**MODEL: 51/55/254/257/262**

**SUBJECT: Fuel Line Tank Grommet / Air Box Grommet**

Fuel Line Crankcase  
Grommet

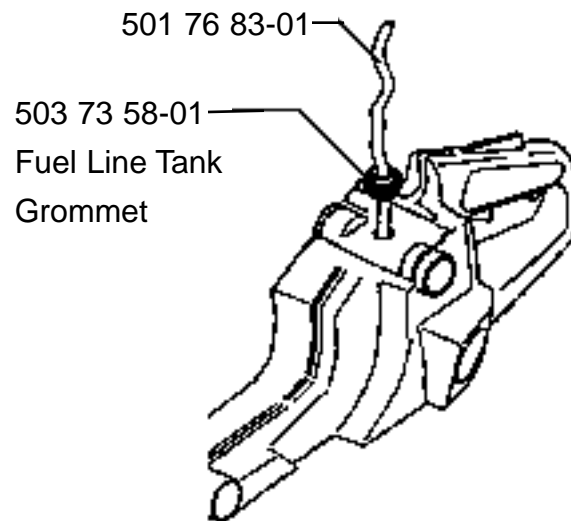
On some Illustrated Parts List these parts have been left out. The fuel line grommet can be fitted on earlier models by drilling the hole for the fuel line to 8 mm (0.315").
